Subject: Deepwater Horizon

Reference: Acceptance of Well Control Equipment

WEST Report # 1040

Section 2: Recommendation Summary and Disposition

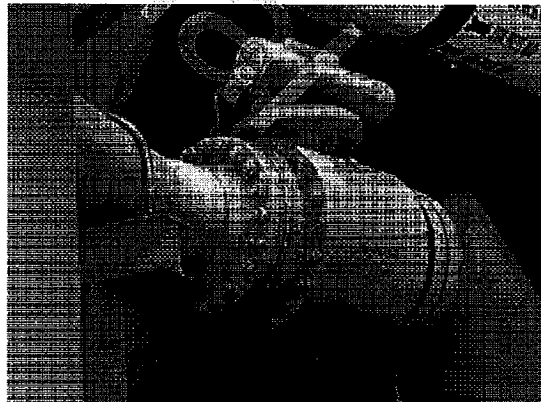
5. The port overboard ball valve leaked and two repair kits were ordered. This should be repaired promptly to be certain no other parts are required to fix the leak (for example, if the ball was damaged, this is not part of the repair kit).

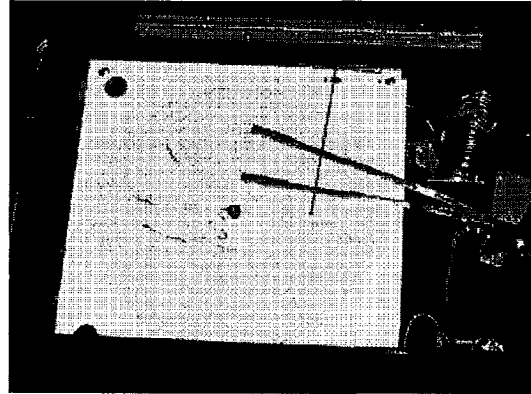
6. A spare chart recorder should be obtained so the one on the unit can be sent in for repair and calibration. The low pressure pen and high pressure pen could not be used together due to interference when a long enough pen was put on the low pressure arm to get it to contact the chart, see the photo to the right. The gauges were also in need of calibration.

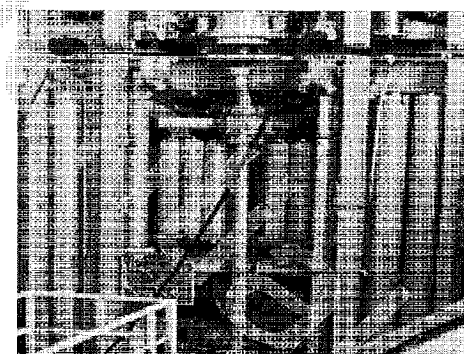
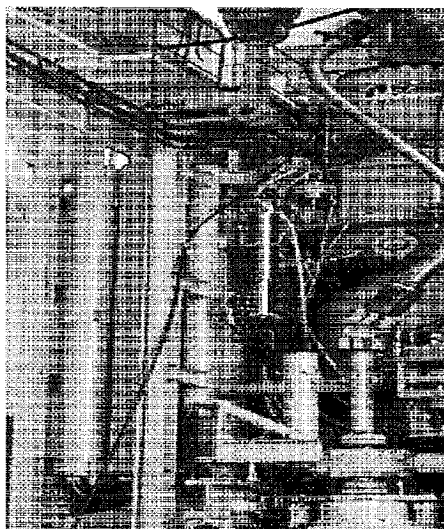
5. The riser spider should be modified to clear the slip joint when picking it up or laying it out. The ideal time to do this would be now, as there may still be an interference problem when running the BOP. The photo below left shows minor damage that occurred. The photo below right shows the interference that caused the damage from the slipjoint. Normally this will be run after the BOP and riser, which should drop the riser spider by a small amount.

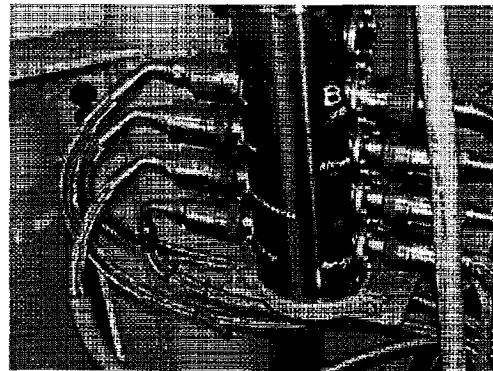
8. The riser connection box (RCB) as seen to the right should have the latest update with individual fuses that are resettable. This provides redundancy for the system. Also, Cameron is investigating the effect of losing the RCB and how it would effect the full system.

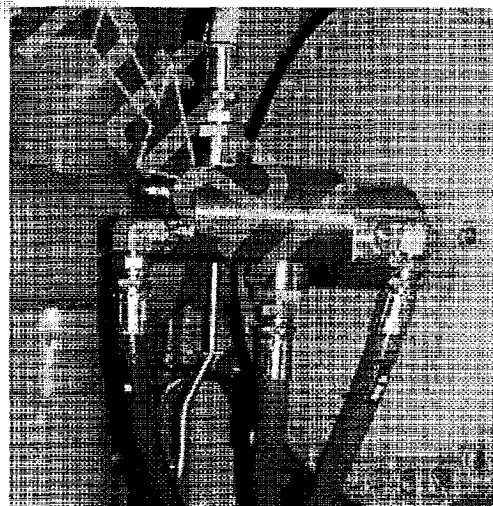
10. Mark II Gilmore stackable shuttle valve on the super shear ram, shown to the right, should have the Mark III HD shuttles installed.

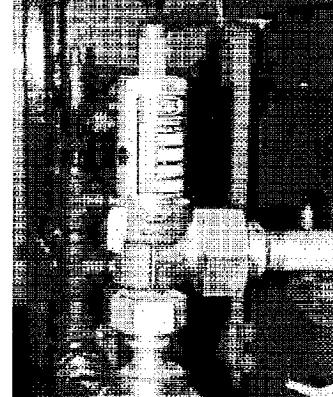
The Seacon cable connectors chosen by Cameron have pressure ratings that correspond with a depth of only 6,750 ft even though the control system may be rated for as much as 10,000 ft. The connector of part number AWQ-4/24-S-BC-DO has a mated pressure rating of 10,000 psi and an open face rating of 3,000 psi. This means that when all six of the cable plugs are properly mated to the bulkhead connector, the assembly can withstand 10,000 psi. A loose or disconnected fitting in any one of the six connectors results in a decreased pressure rating of 3,000 psi and could cause failure of the solenoid cable.

Steve Donahue will check with Cameron to be certain the Seacon connectors on the Horizon are the 5000 psi open face rating. The recommendation is to use Seacon's connector of part number AWQ-4/24-BC-SP with an open face mating pressure rating of 5,000 psi (approximately 11,250 ft water depth). Although replacement of each of these connectors is a tedious process that should be carefully tested upon completion, the cost of replacing the Seacon connectors is estimated at much less than the replacement cost of a flooded SEM.

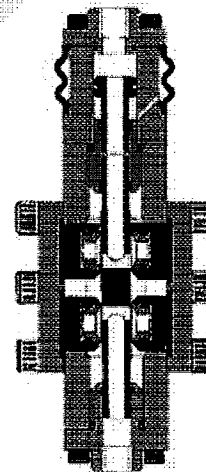
Cameron ½" Unbalanced Shuttle Valves Hydrostatic Lock - A problem with hydrostatic lock was witnessed on one rig. The problem was isolated to either the ½" unbalanced shuttle valve or a ¾" pilot operated check valve in the same circuit, but could be isolated no further. Both valves were removed and replaced with different types of components and the problem did not recur. It should be pointed out that these same valves are currently in use on other rigs separately and have not caused problems.

The ½" unbalanced shuttle valves should be closely monitored to ensure hydrostatic lock does not occur. The ½" unbalanced shuttle valve can be seen to the right.

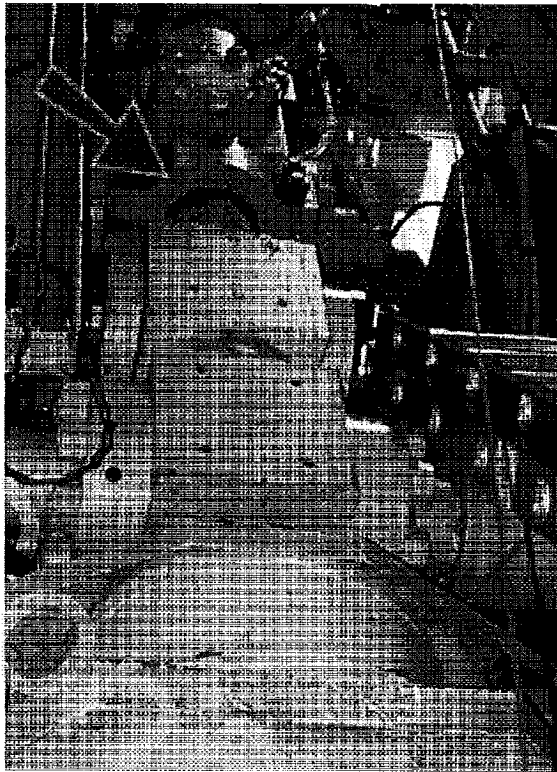
6.1 The arrow to the right points to the outlet on the lower annular bleed valves requiring AX gasket change out due to a leak found during wellbore pressure testing. This outlet and the connection shown below are the ones affected by the 1/4" upward movement when the choke mini connector is unlatched. Cameron is supposed to demonstrate why the 1/4" movement is acceptable.
